Remarks

Atty. Dkt. No. 1875.5620001

FIG. 6C

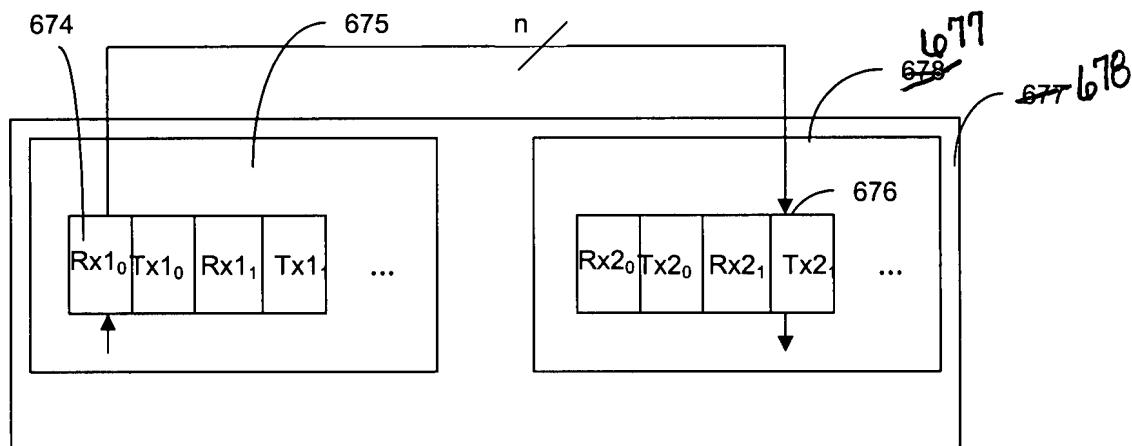
The current Office Action states on page 2, section 2, that the drawings are objected to “because the arrow indicating common substrate 678 in Figure 6C and disclosed in paragraph [0058] is pointing at the core rather than at the substrate.” In order to address this objection, Figure 6C is sought to be amended to switch reference numbers 677 and 678 such that reference number 677 points to the core and reference number 678 points to the substrate as discussed in paragraph [0058] of the originally filed specification. These changes add no new matter. Accordingly, Applicants respectfully request that the objection to the drawings be reconsidered and withdrawn.

In the specification, the title is sought to be amended to correct a typographical error. In the drawings, Figure 6C is sought to be amended to switch reference numbers 677 and 678 to correspond with the discussion found in paragraph [0058] of the specification as originally filed. Annotated and replacement drawing sheets showing Figure 6C are submitted herewith. These changes introduce no new matter, and their entry is respectfully requested.
